ALAMEDA COUNTY
HEALTH CARE SERVICES

August 3, 2006

Subject: Fuel Leak Case No. RO0000207, Mission Valley Rock and Asphalt, 7999 Athenour Way, Sunol, CA

Subject: Fuel Leak Case No. RO0000207, Mission Valley Rock and Asphalt, 7999 Athenour Way, Sunol, CA – Work Plan Approval

Figure 2

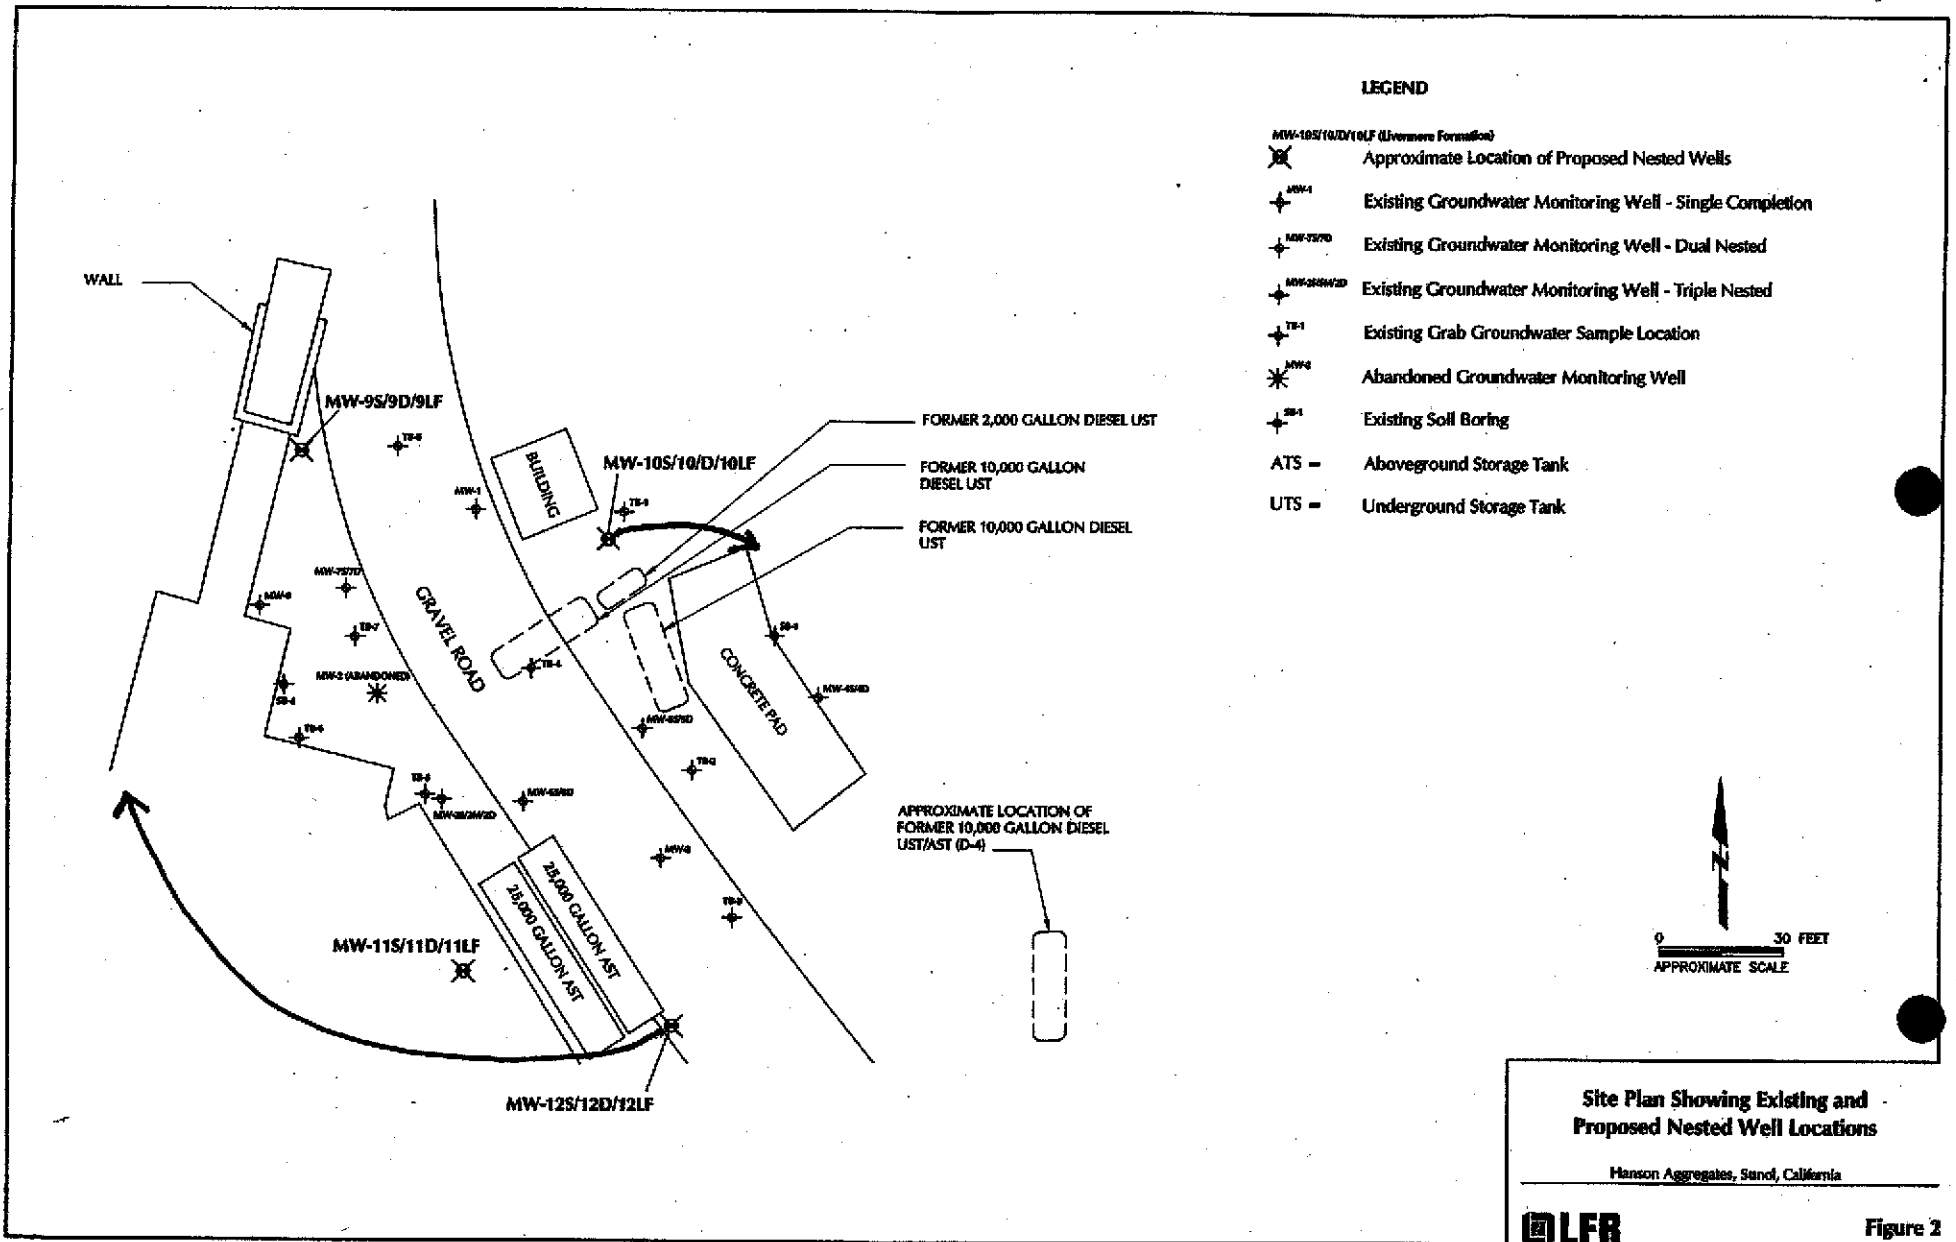
- 2. Plume Delineation to the East.** Because the predominant hydraulic gradient is apparently to the east, we request that proposed monitoring well cluster MW-10S/10D/10LF be moved to a location east of the former underground storage tanks (USTs) as shown on the attached figure.

3. **Plume Delineation to the West.** We request that proposed monitoring well cluster MW-12S/12D/12LF be moved to a location west of the former underground storage tanks (USTs) and monitoring well MW-7D. During recent groundwater monitoring events, elevated concentrations of petroleum hydrocarbons have been detected in groundwater samples from well MW-7D. The screen interval for well MW-8 is too shallow to monitor the deeper water-bearing zone. Therefore, we request that well cluster 12S/12D/12LF be installed to define plume extent to the west as shown on the attached figure.

8. **Figure 2.** Figure 2 depicts the former 2,000-gallon UST as a diesel UST although the text and historical records indicate the UST was used to store gasoline. Please revise Figure 2 or the text accordingly in future reports.

| PROJECT NO. EM-5009A | FIGURE 2 |

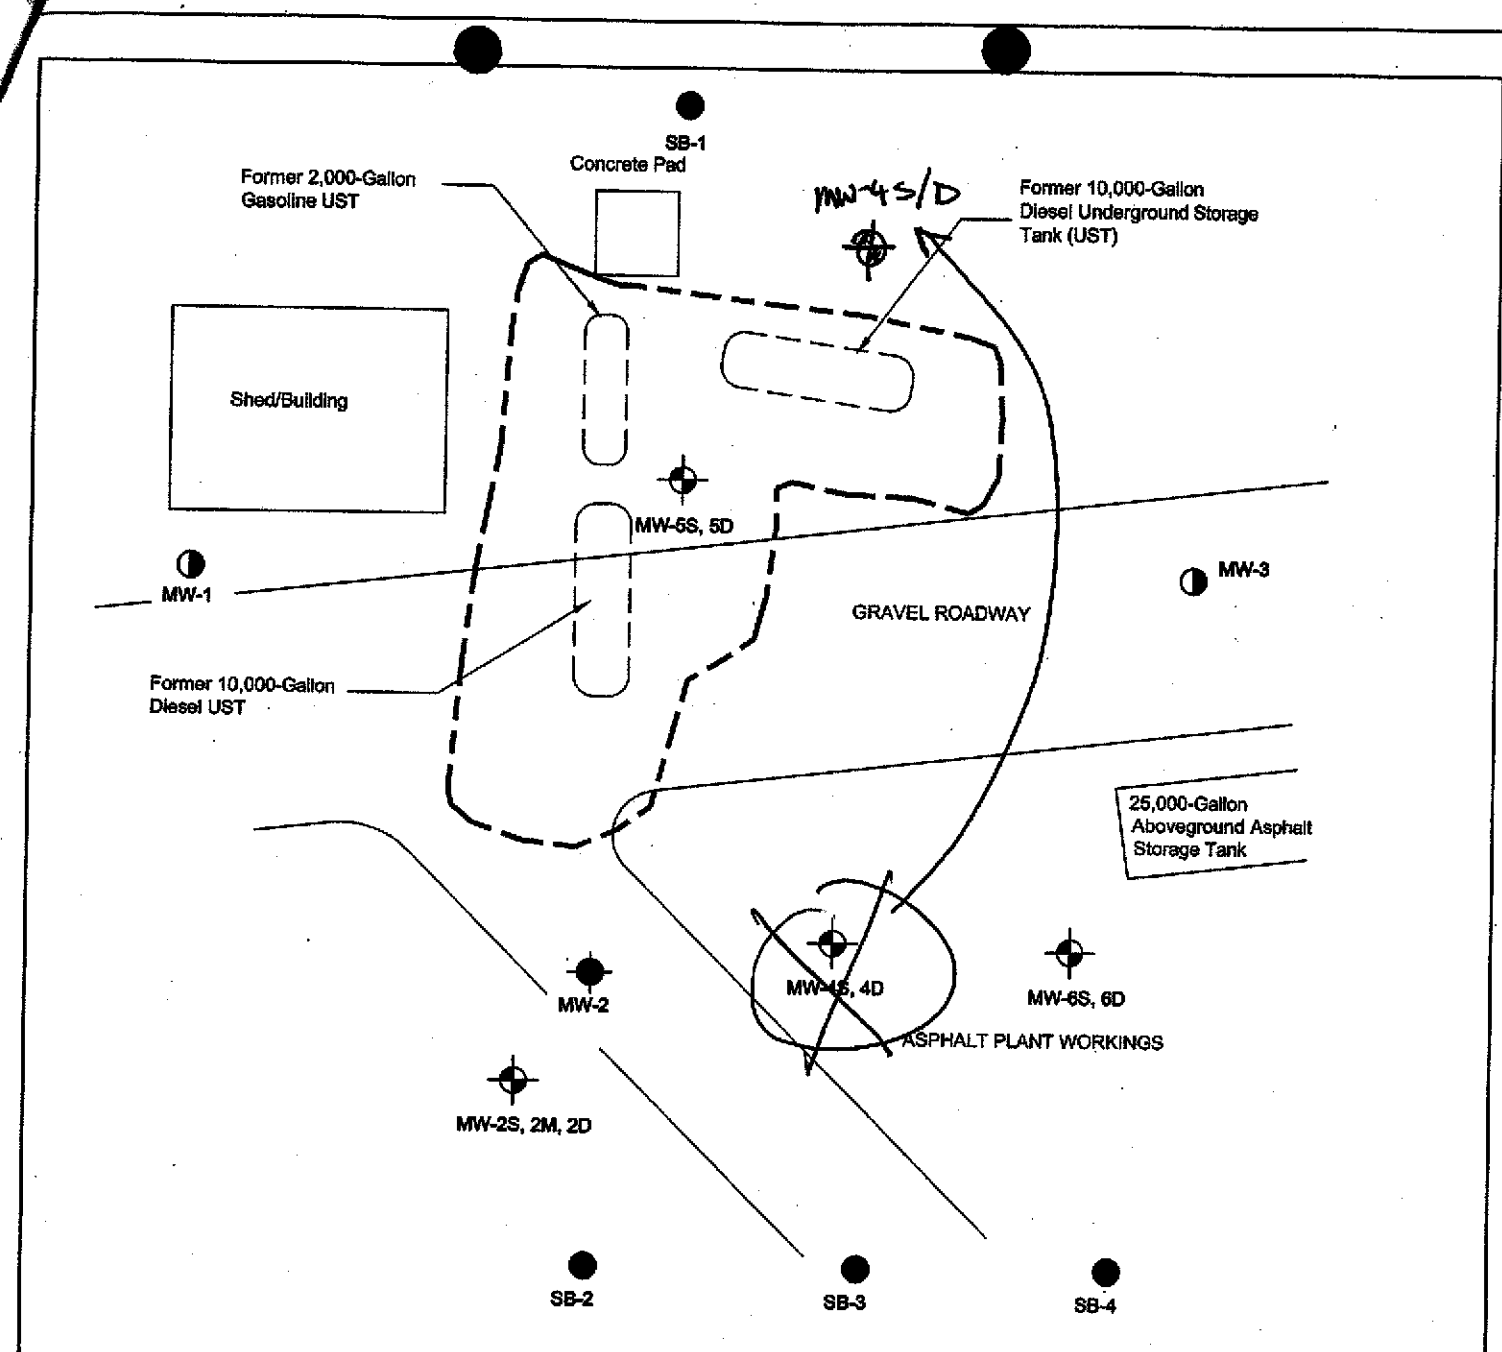
4. Proposed monitoring wells MW-4 S/D be located in the apparent downgradient direction from the former USTs, as proposed on March 22, 2004 (see attached figure);
